## STAFF REPORT

**AGENDA ITEM:** Fields of St. Croix 1st Addition Residential Street Parking Restrictions

**ISSUE BEFORE COUNCIL:** Should the city council approve revisions to the parking restrictions or to the parking restriction signage plan that was implemented as part of the Fields of St. Croix 1st Addition Street Improvement project?

PLAN CHANGES REDUCES #SIGNS  
FROM 8 to 4

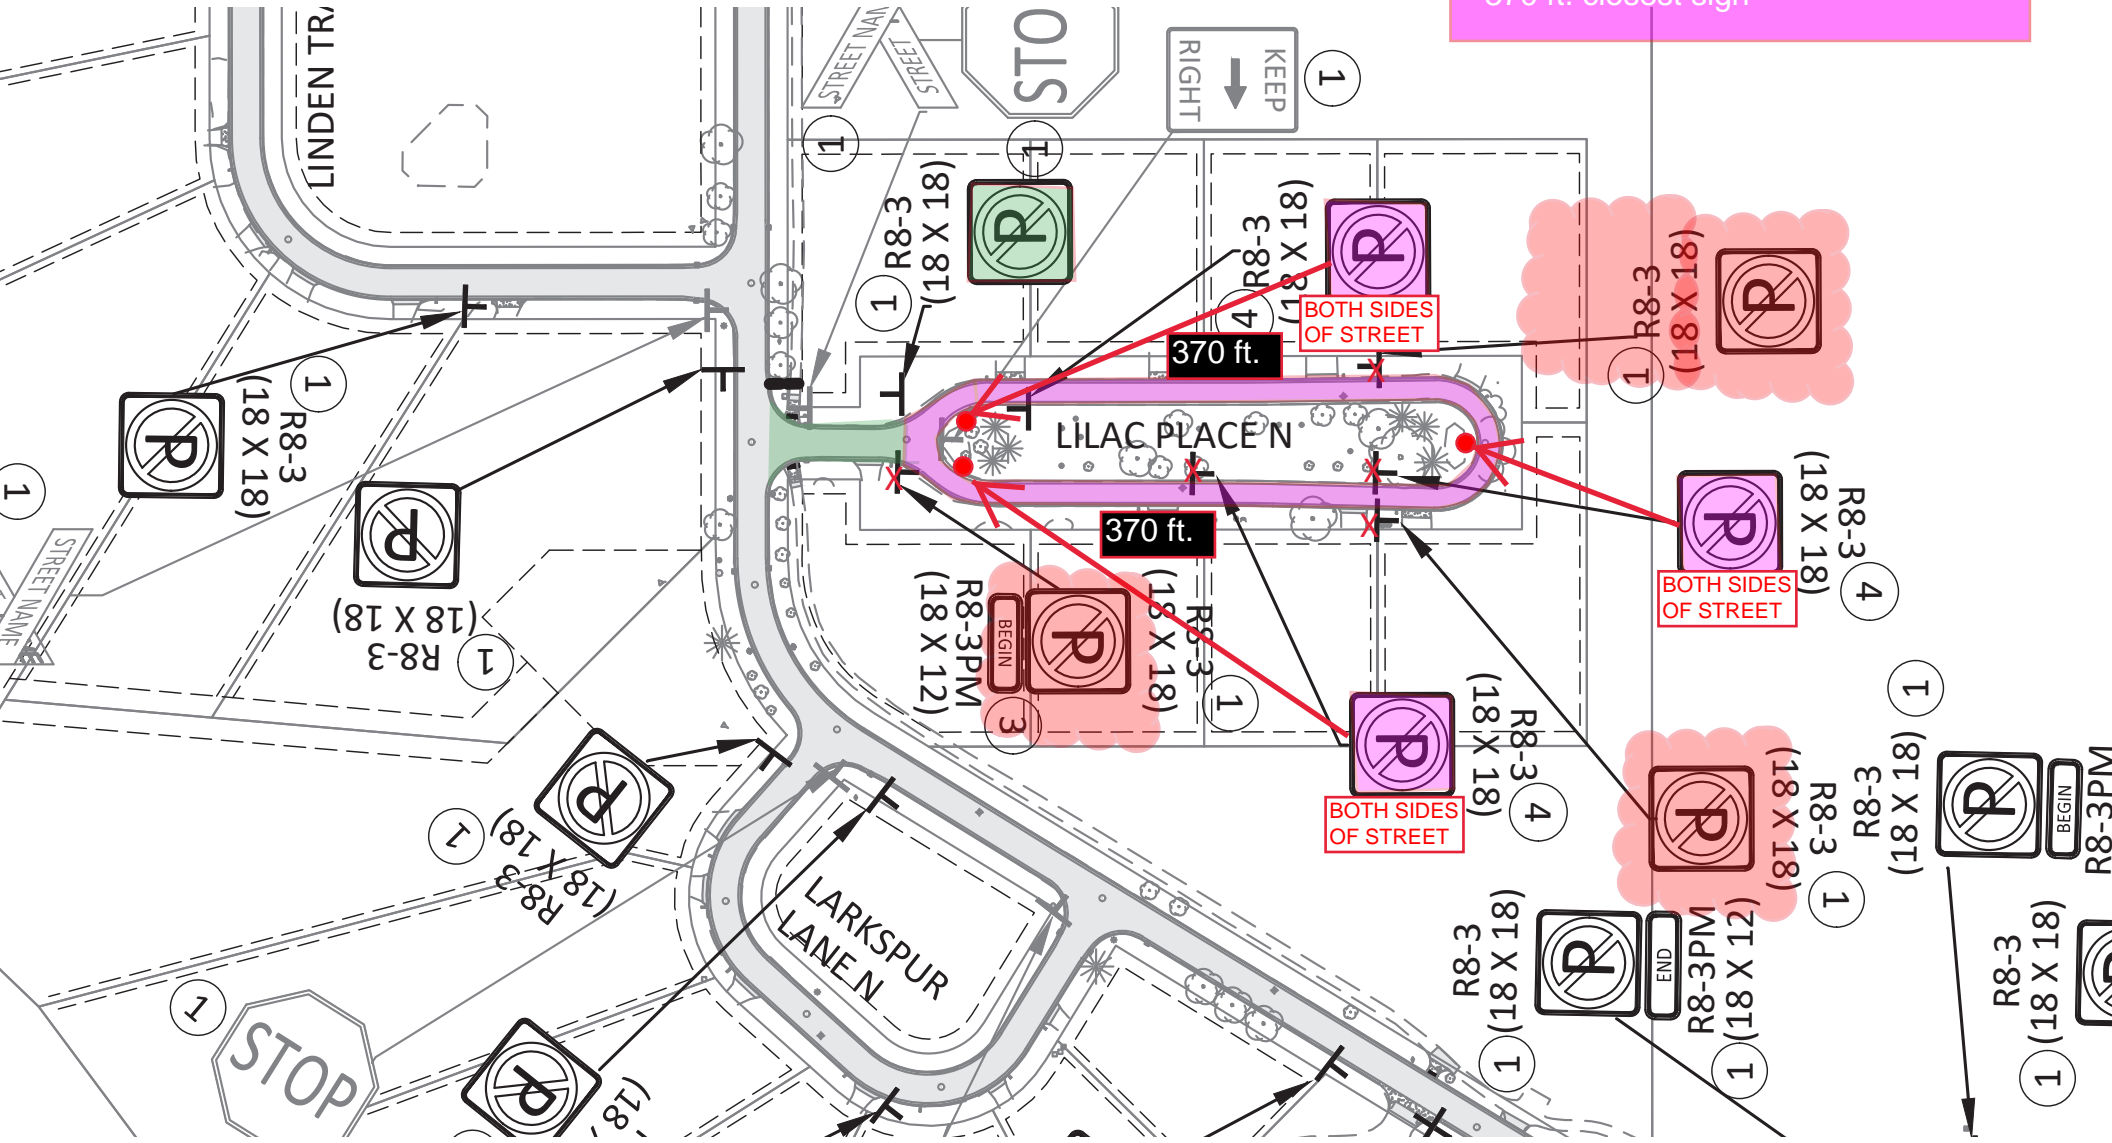
1. Lilac Way North: Reduce overall number of no parking signs from 8 down to 4, as follows:
  - Relocate 3 signs per the attached exhibit and add placards to the 3 signs “BOTH SIDES OF STREET”.
  - Remove 4 existing no parking signs as depicted on the exhibit.
2. Lilac Place North: Reduce overall number of no parking signs from 7 down to 4, as follows:

LILAC WAY NORTH  
-- 95 ft. Parking one-side  
-- 1 sign

LILAC WAY NORTH  
-- 885 ft. Loop Street  
-- Lane width is 17 ft.  
-- No parking both sides  
-- 3 signs  
-- 375 ft. closest sign

PLAN CHANGES REDUCES #SIGNS  
FROM 7 to 4

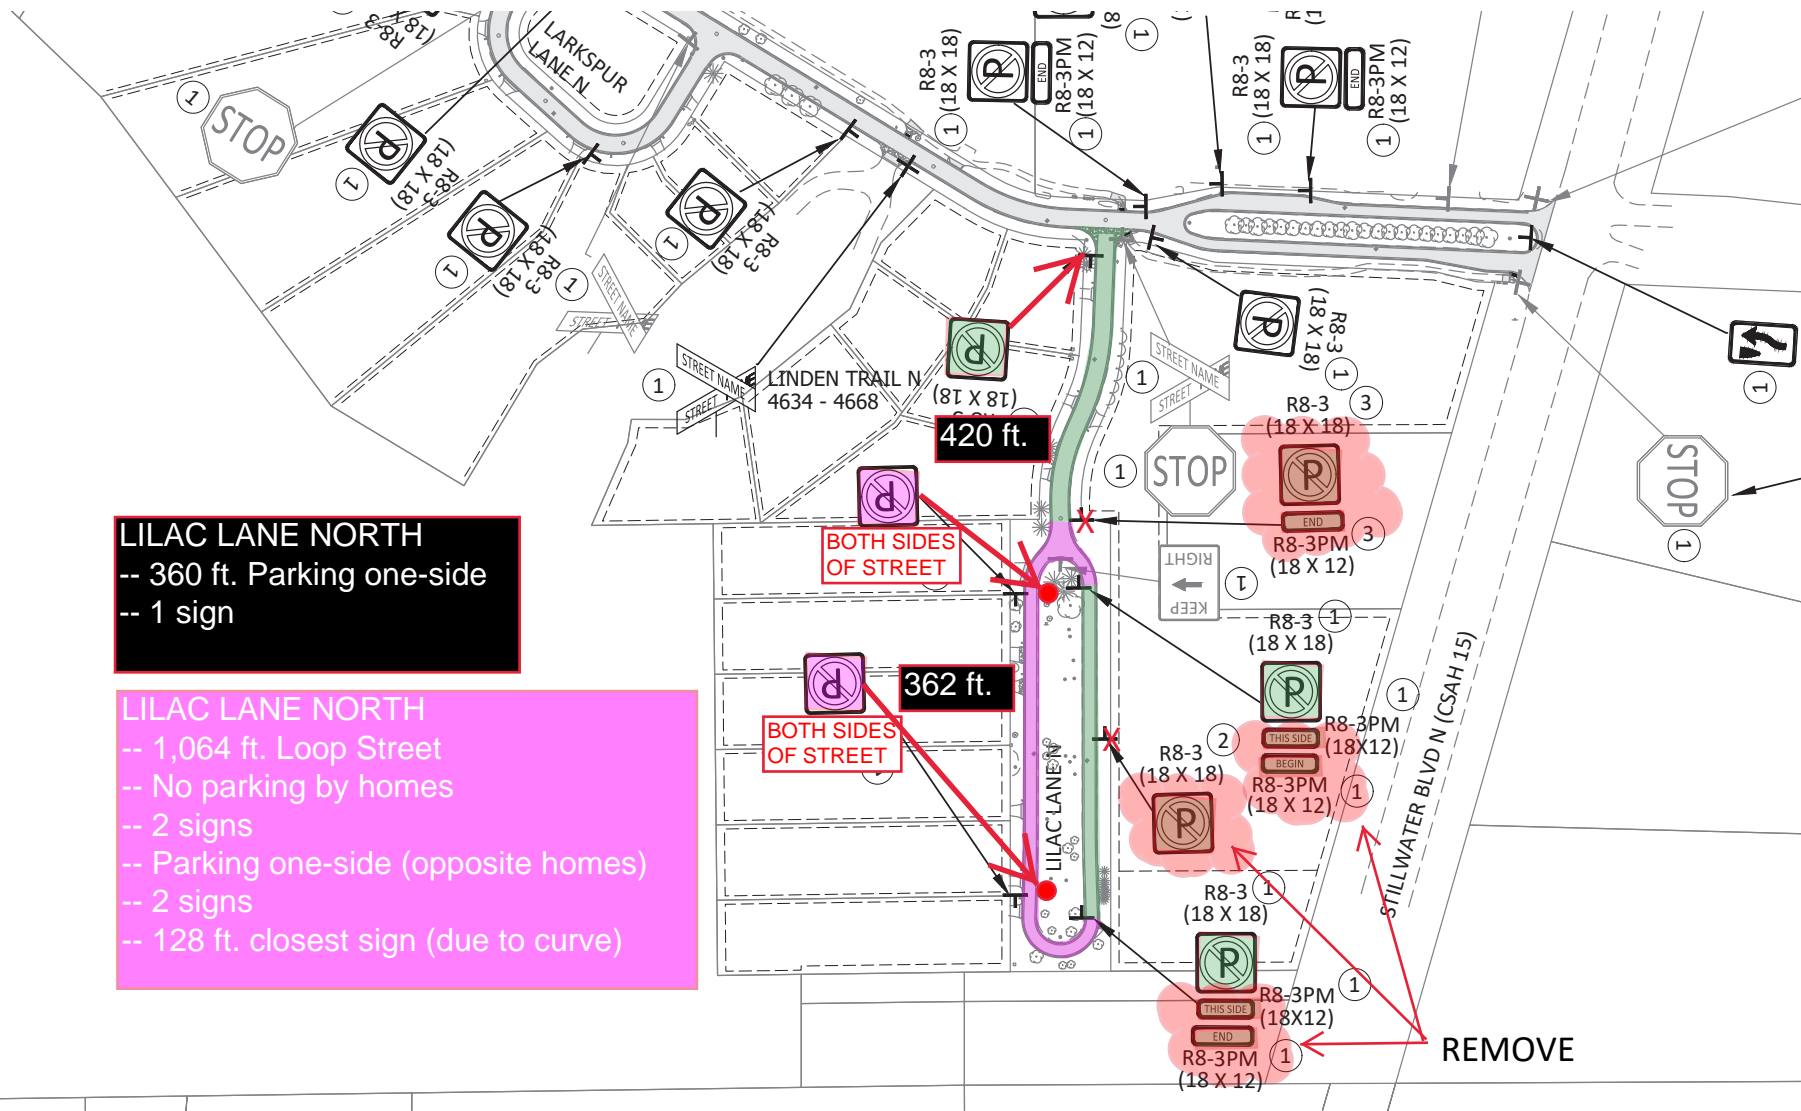
- Relocate 3 signs per the attached exhibit and add placards to the 3 signs “BOTH SIDES OF STREET”.
  - Remove 4 existing no parking signs as depicted on the exhibit.
3. Lilac Lane North: Reduce overall number of no parking signs from 7 down to 5, as follows:
    - Relocate 2 signs per the attached exhibit and add placards to the 2 signs “BOTH SIDES OF STREET”.
    - Remove 2 existing no parking signs as depicted on the exhibit.
    - Remove placards from 2 no parking signs “THIS SIDE” and “BEGIN/END”.
  4. Linden Trial North: No changes.
  5. Linden Trial North (Entrance Road).
    - Add placards to the 2 signs “BOTH SIDES OF STREET”.
    - Discussion needed around current dedicated parking bump-out spaces.
  6. Linden Trial North (Loop Street): No changes.
  7. Larkspur Lane North: No changes.

LILAC WAY NORTH  
-- 885 ft. Loop Street  
-- Lane width is 17 ft.  
-- No parking both sides  
-- 3 signs  
-- 370 ft. closest sign

**LILAC LANE NORTH**  
 -- 360 ft. Parking one-side  
 -- 1 sign

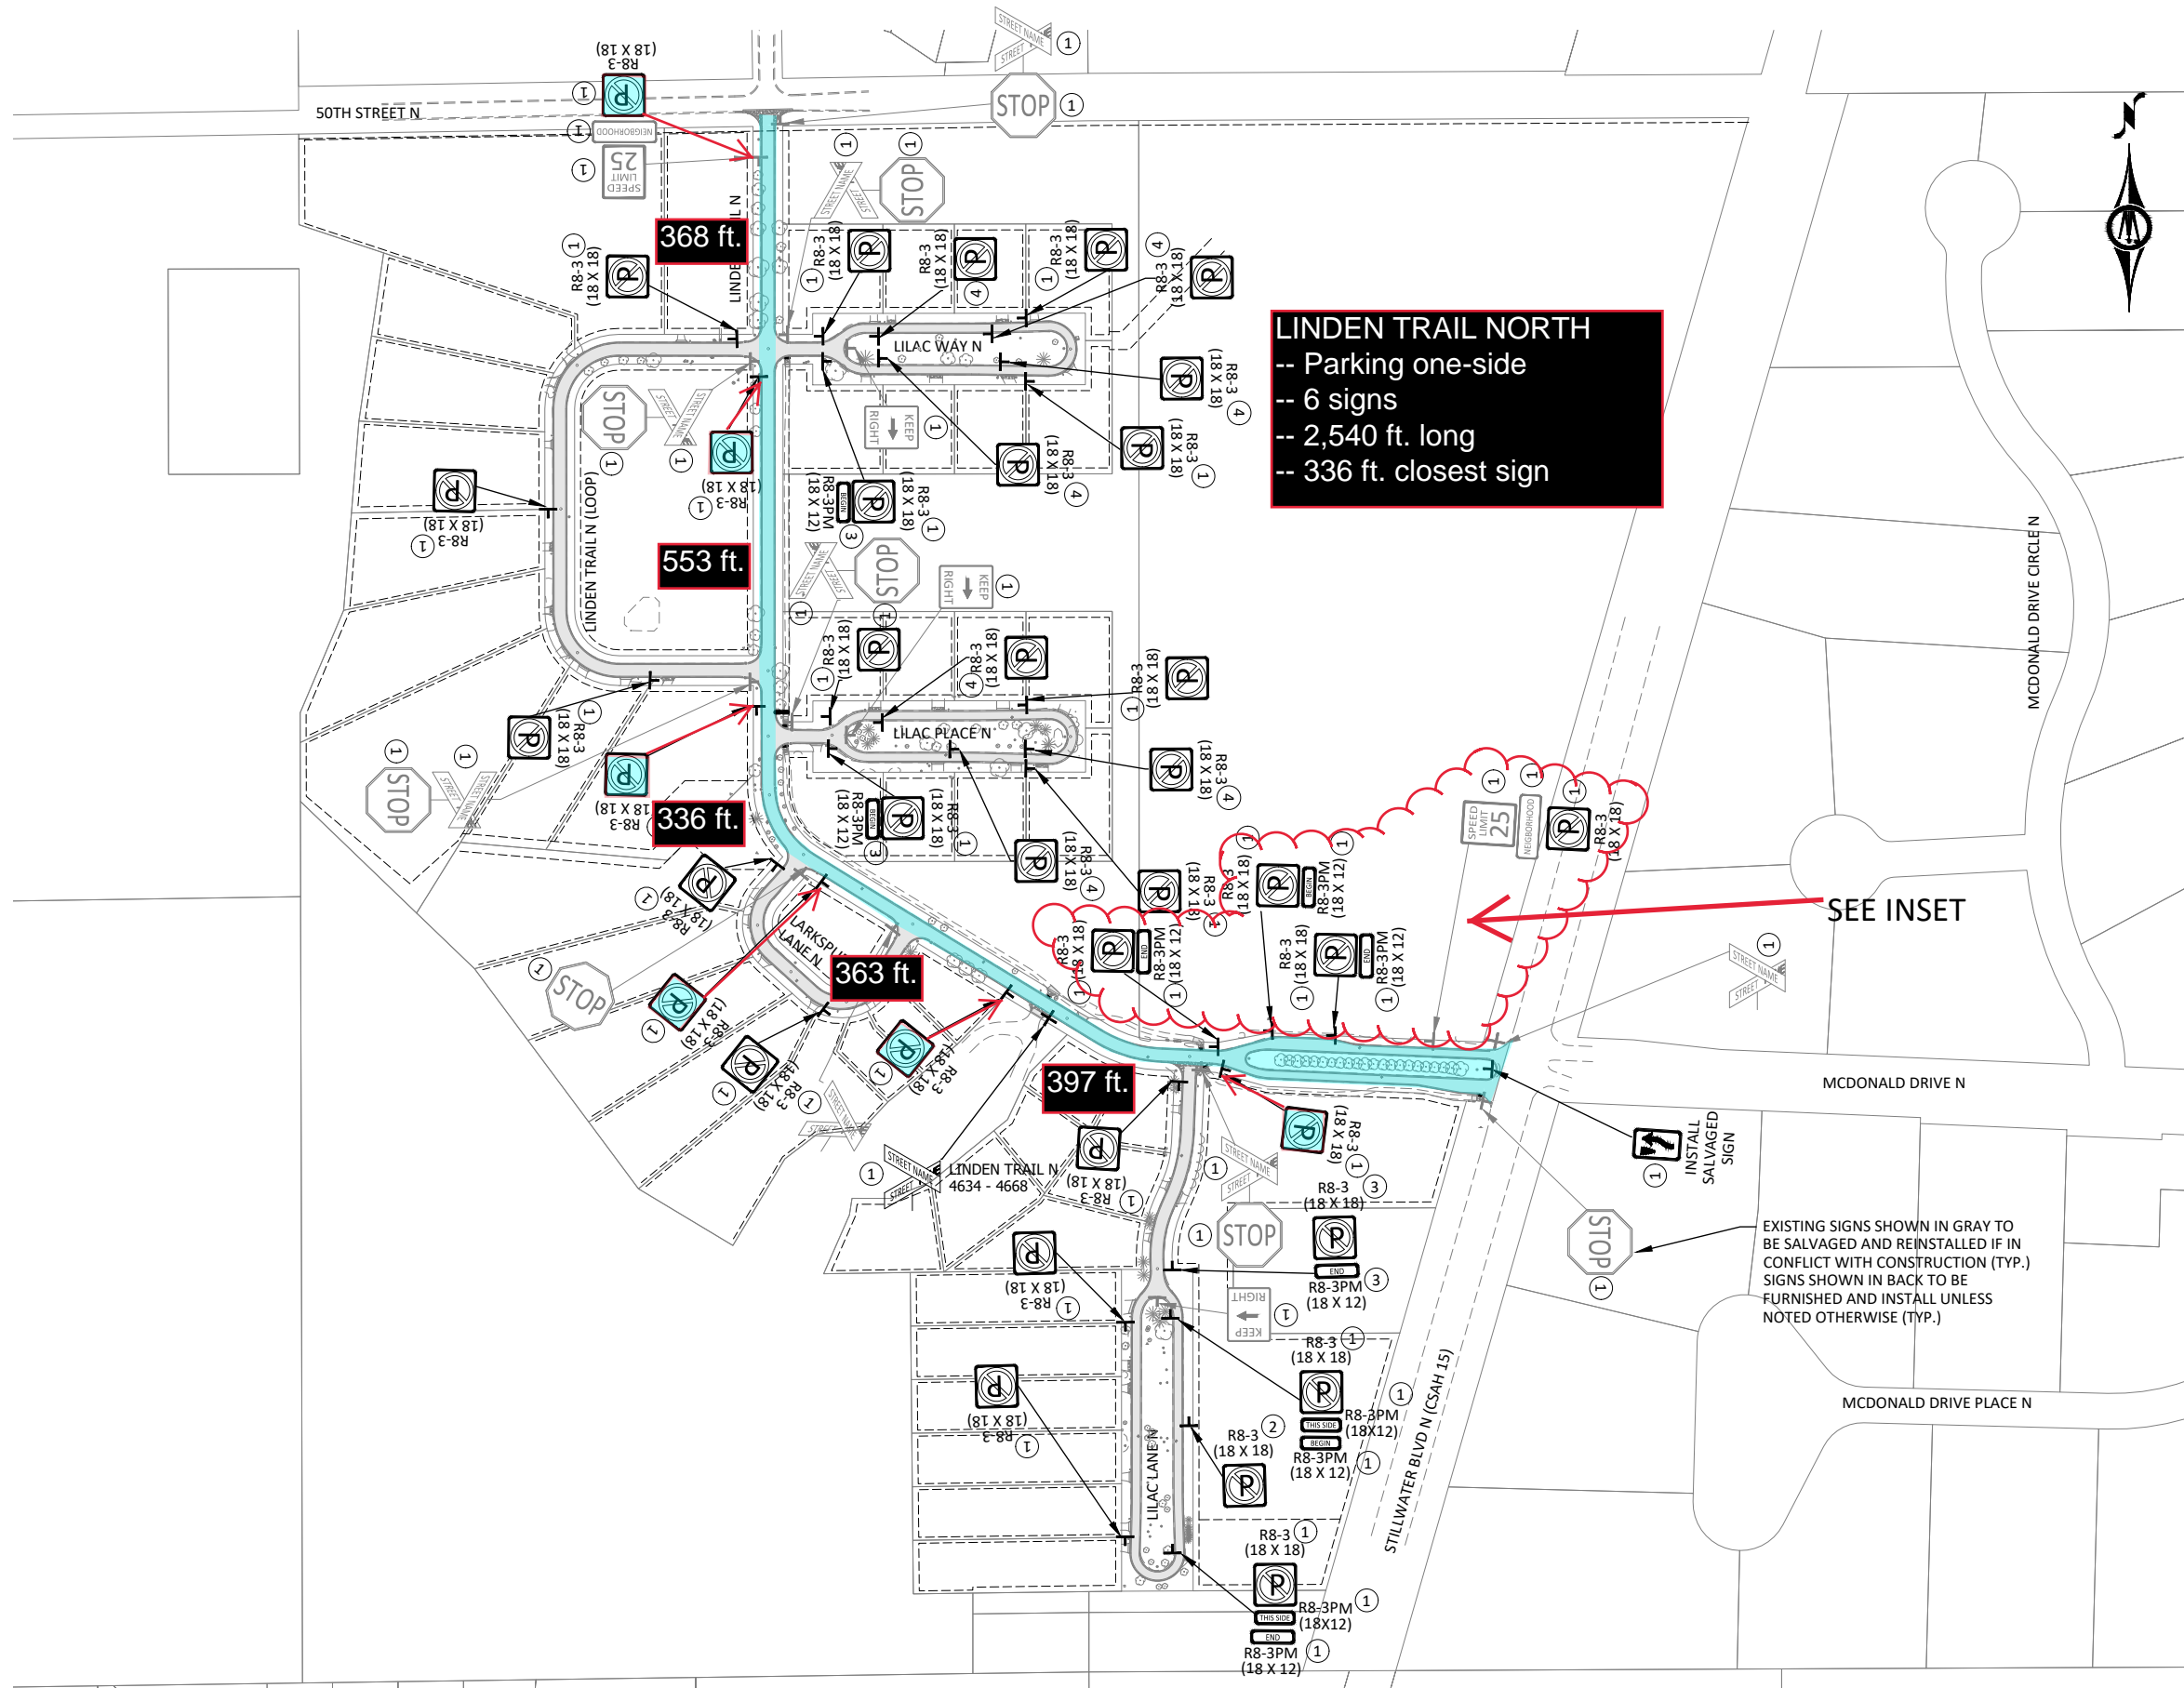
**LILAC LANE NORTH**  
 -- 1,064 ft. Loop Street  
 -- No parking by homes  
 -- 2 signs  
 -- Parking one-side (opposite homes)  
 -- 2 signs  
 -- 128 ft. closest sign (due to curve)
